ADDENDUM 01

July 24, 2026

Bradford Exempted Village Schools
New Athletic Facility
760 Railroad Avenue
Bradford, OH 45308

LPA PROJECT NO. 263401.00

26 FIRST FLOOR PLAN
SCALE | 3/16" = 1'-0"

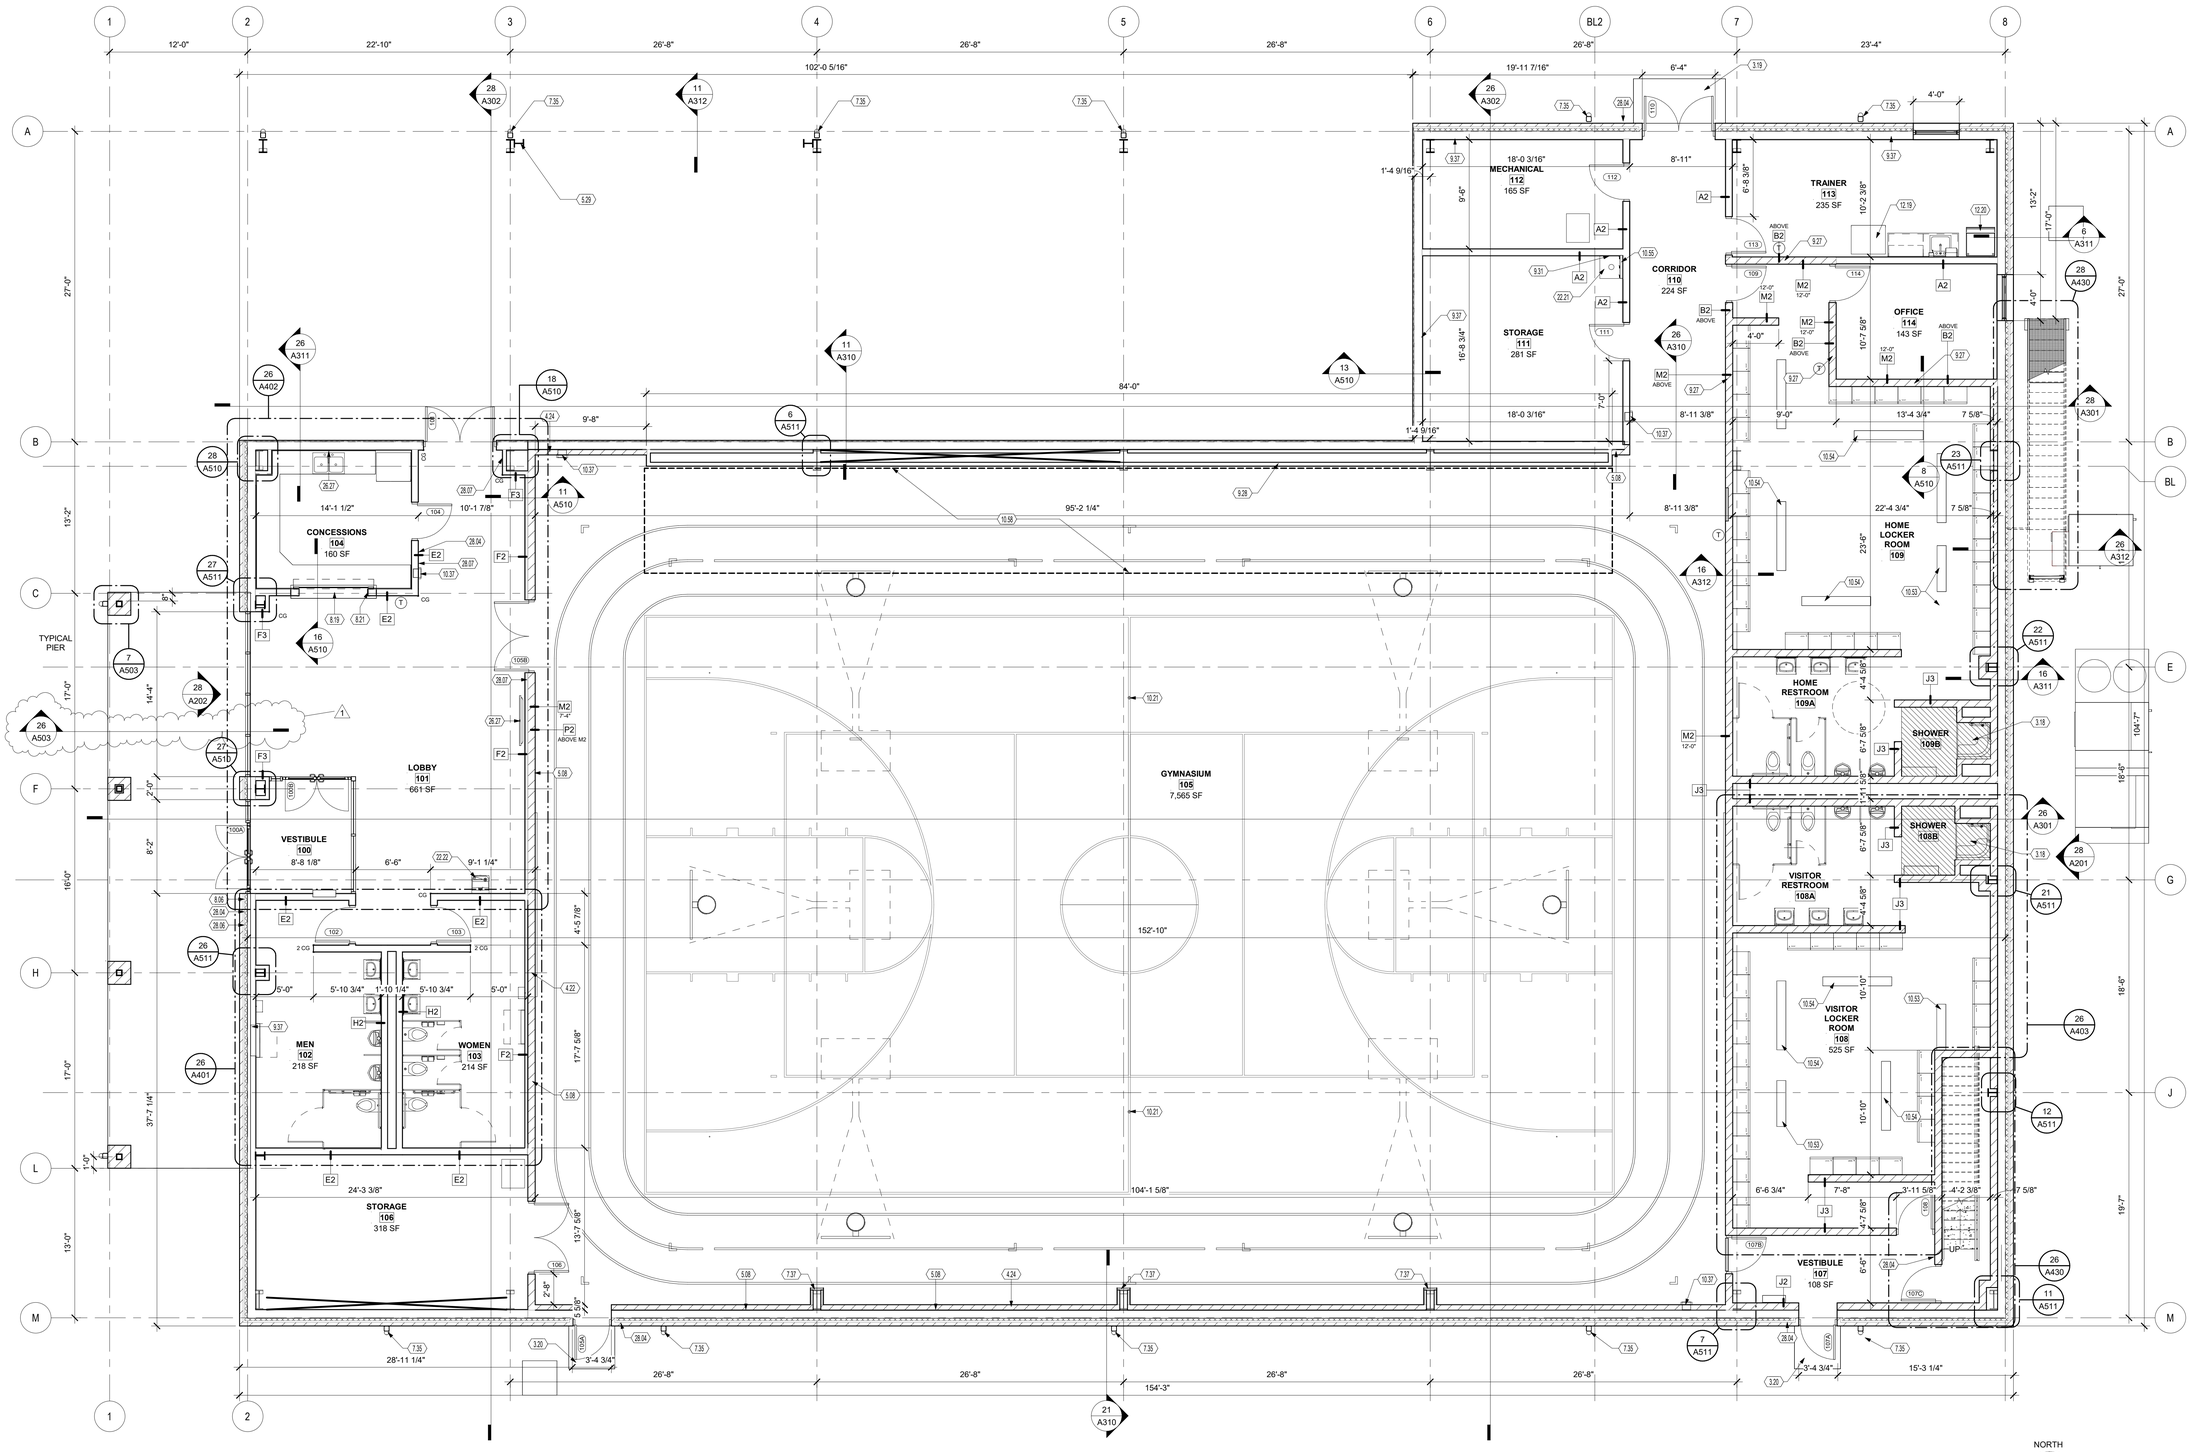
2.2 Sheet A101 – FIRST FLOOR PLAN.

2.2.1 Added Section 26/A503 for front entrance canopy.

26 MEZZANINE FLOOR PLAN

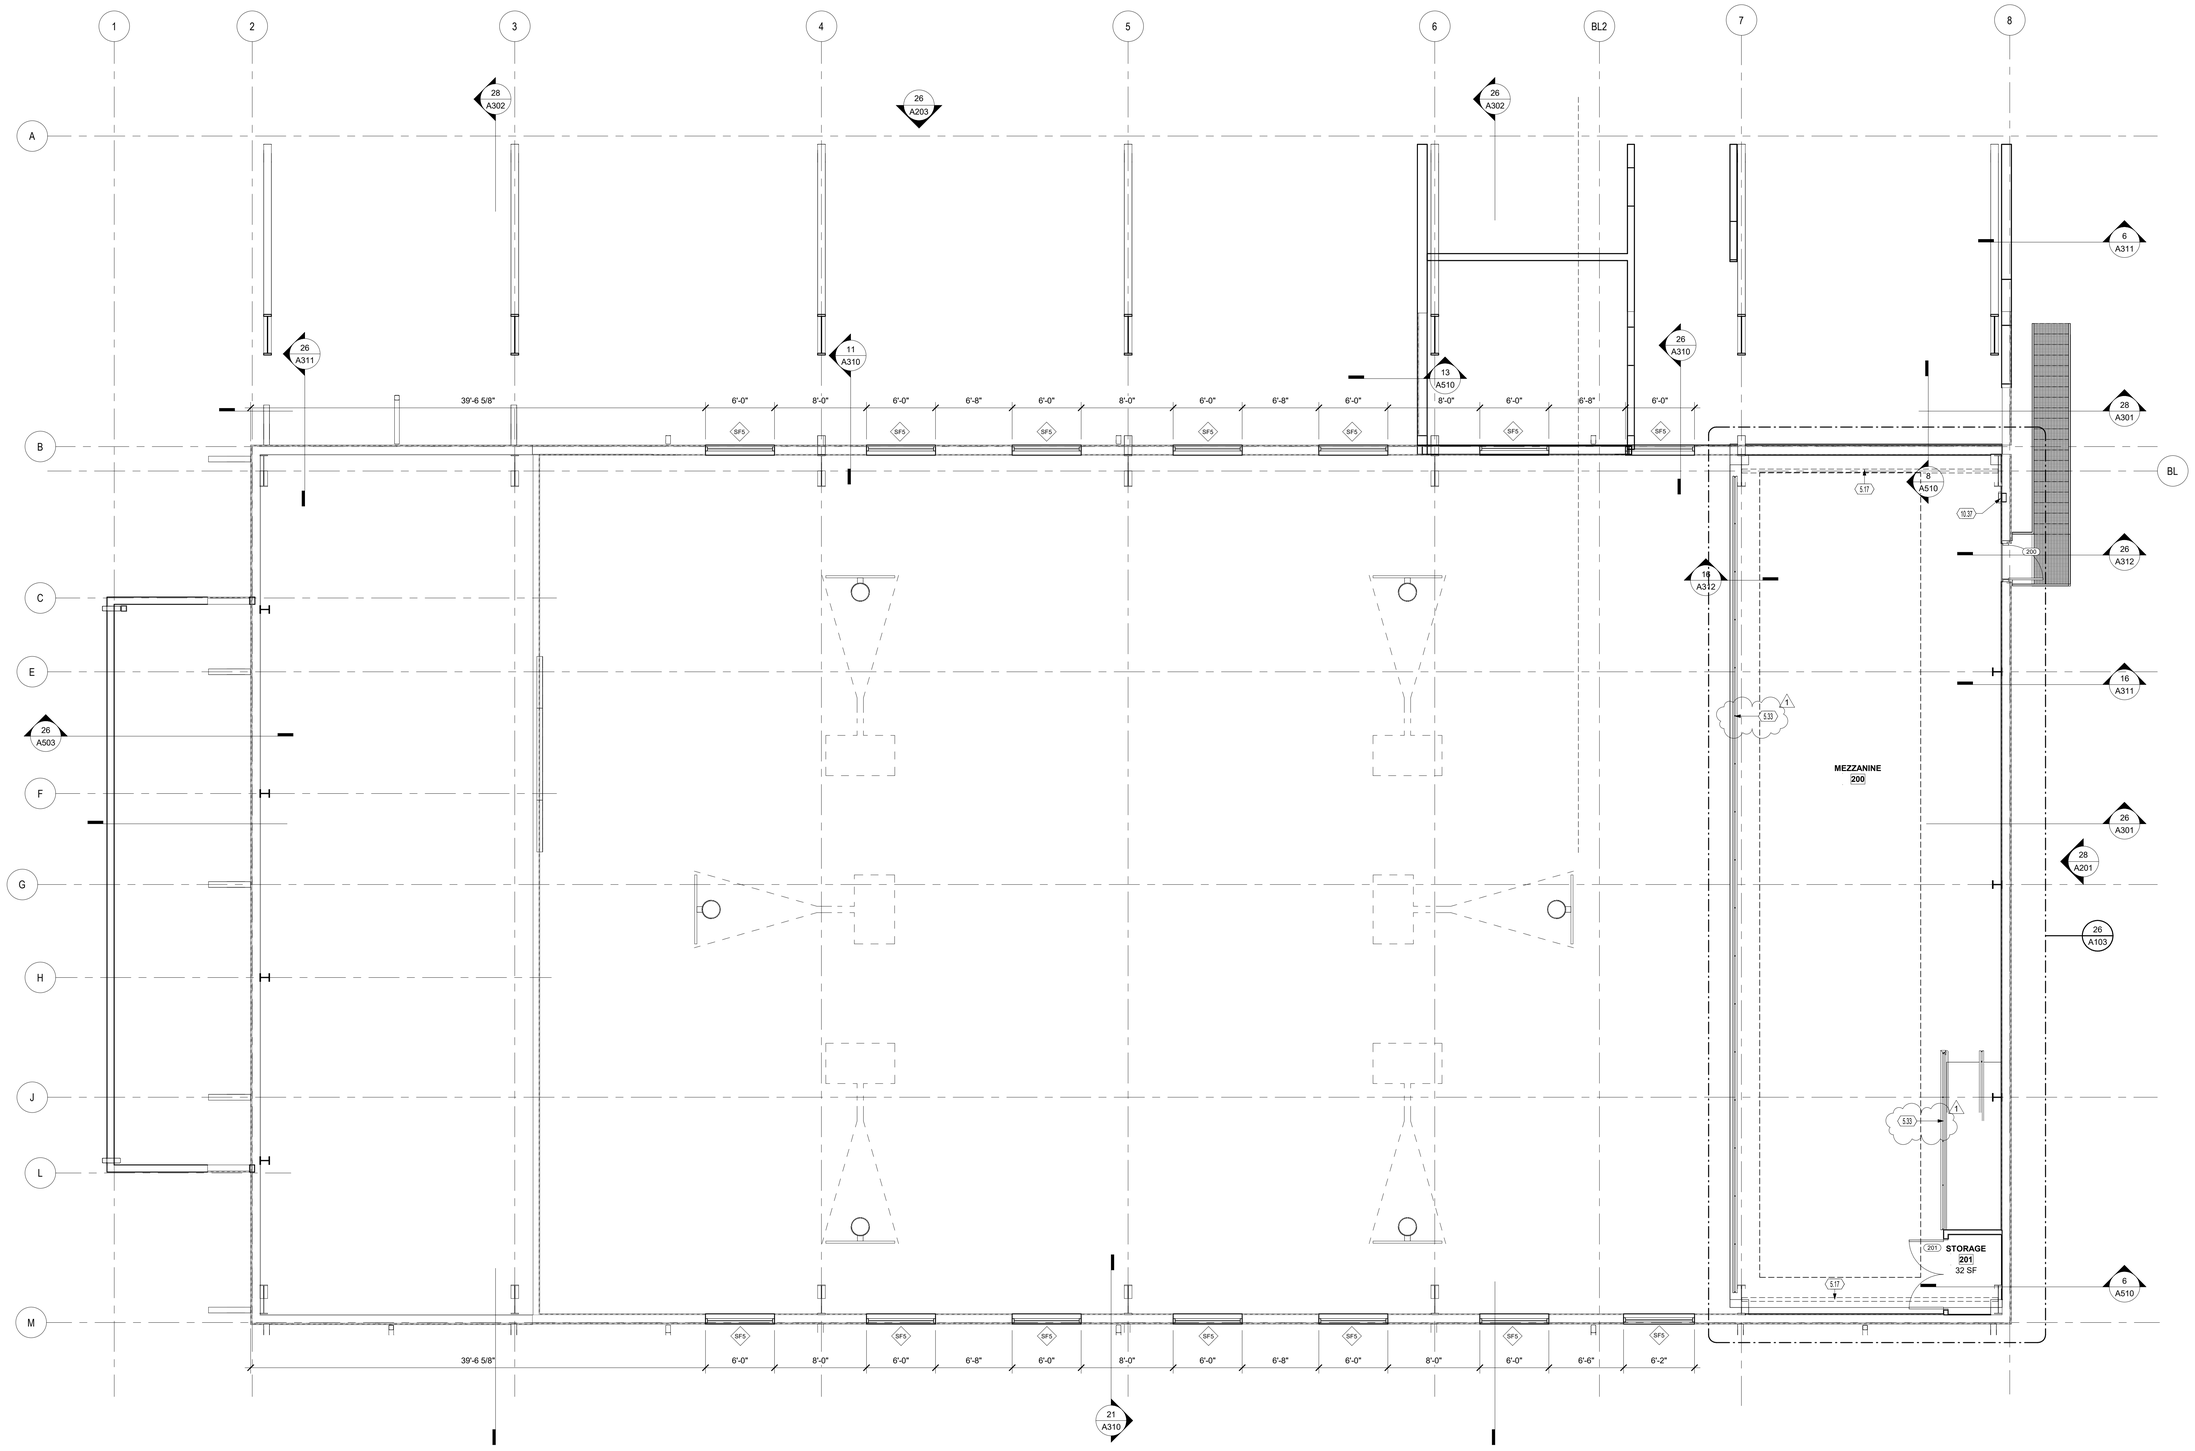
2.3 Sheet A102 – MEZZANINE FLOOR PLAN.

2.3.1 Revised note for mezzanine railing to 5.33. The railing shall be painted steel.

26 ENLARGED GYM STRIPING PLAN
SCALE | 1/4" = 1'-0"

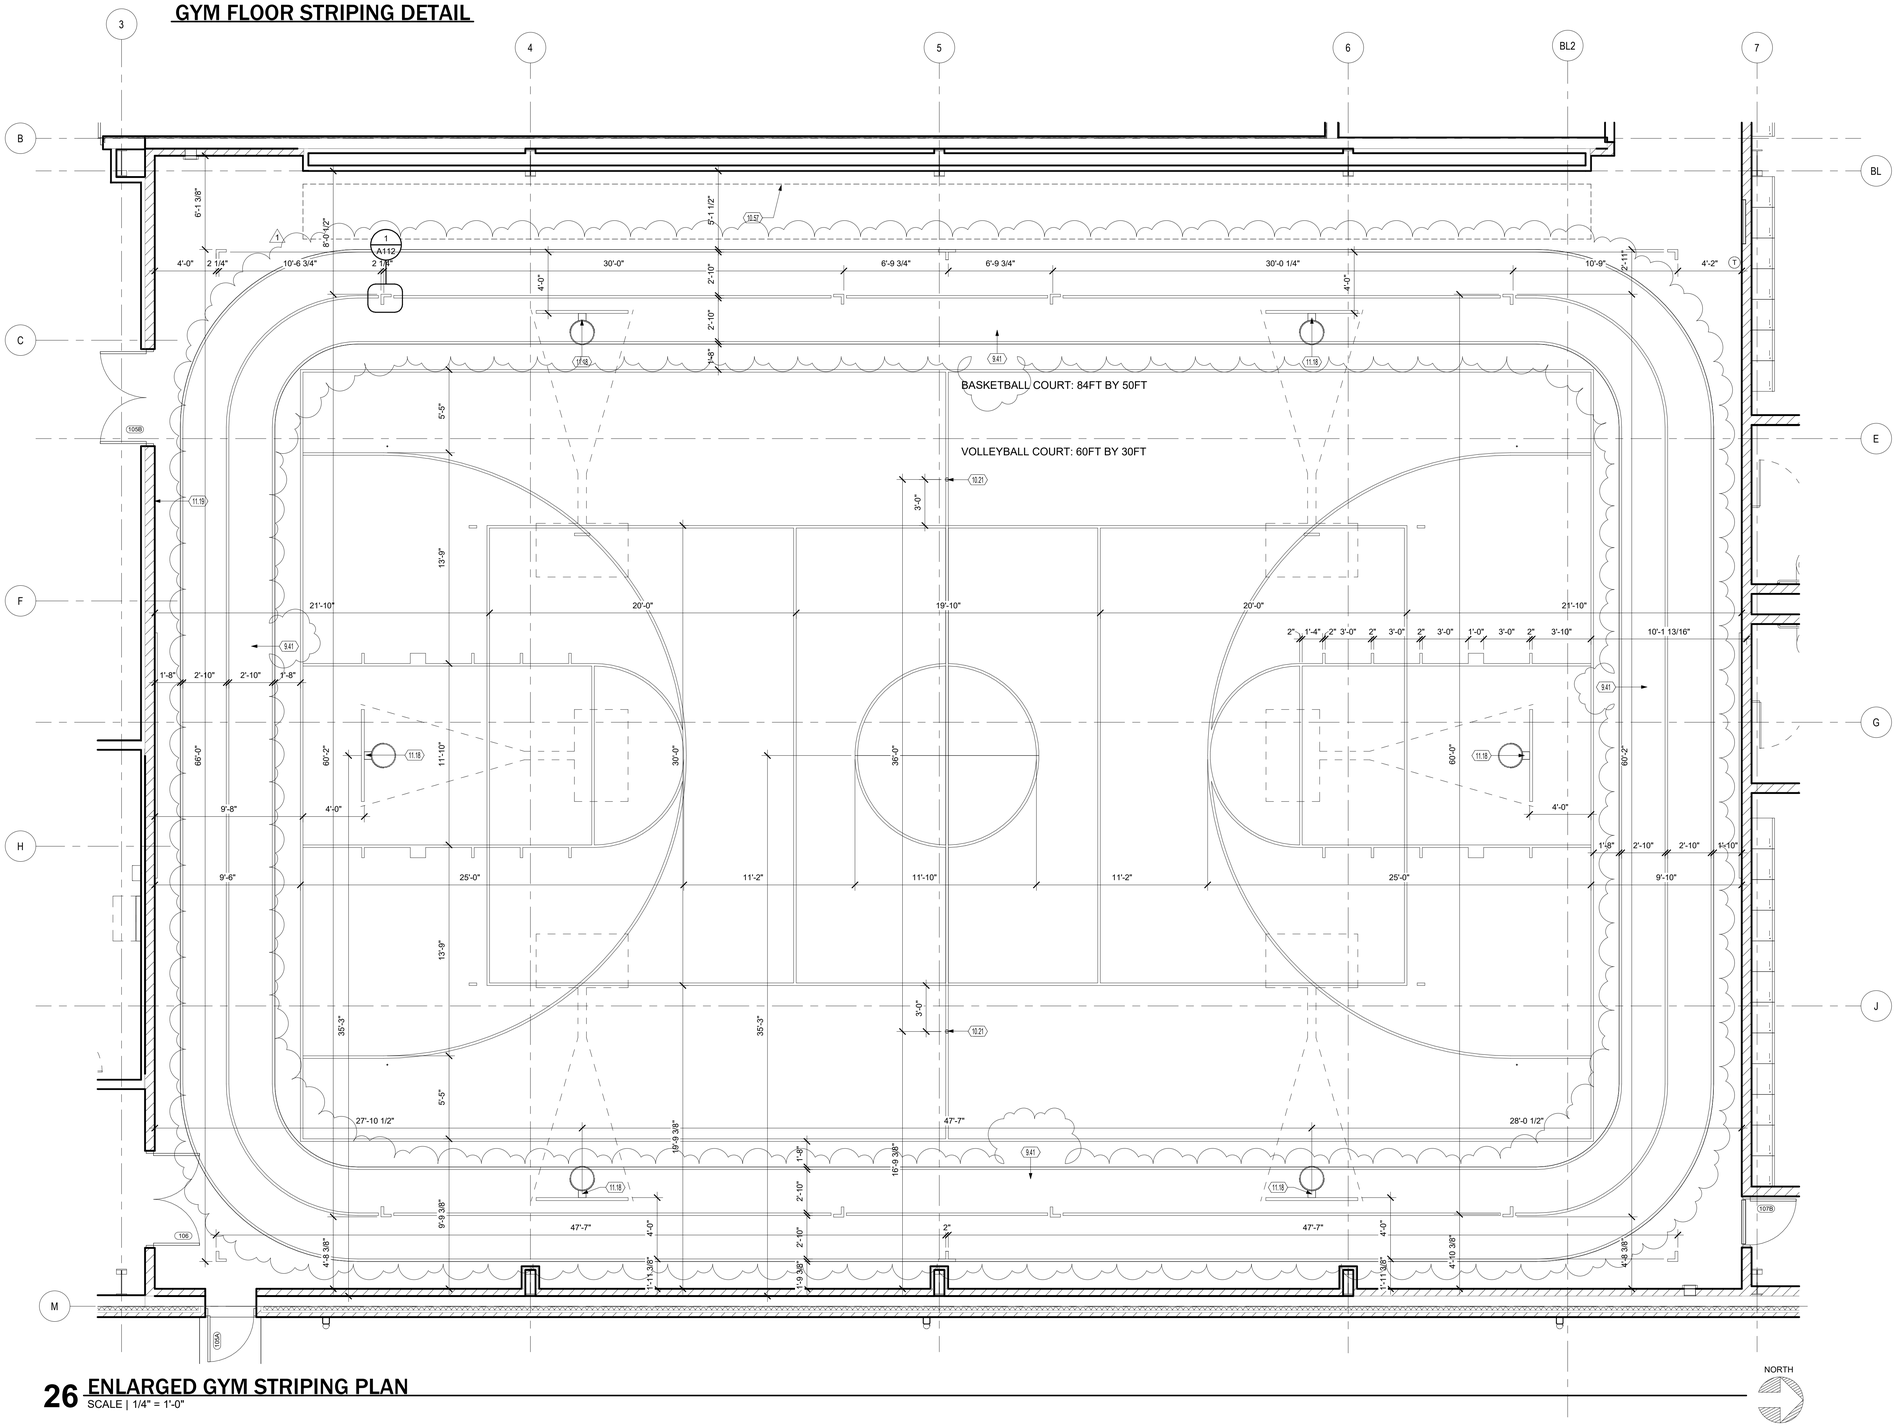
2.4 Sheet A112 – ENLARGED GYM STRIPING PLAN.

2.4.1 Added note 9.41 indicating that the walking track will be painted a contrasting color from the main gym floor.
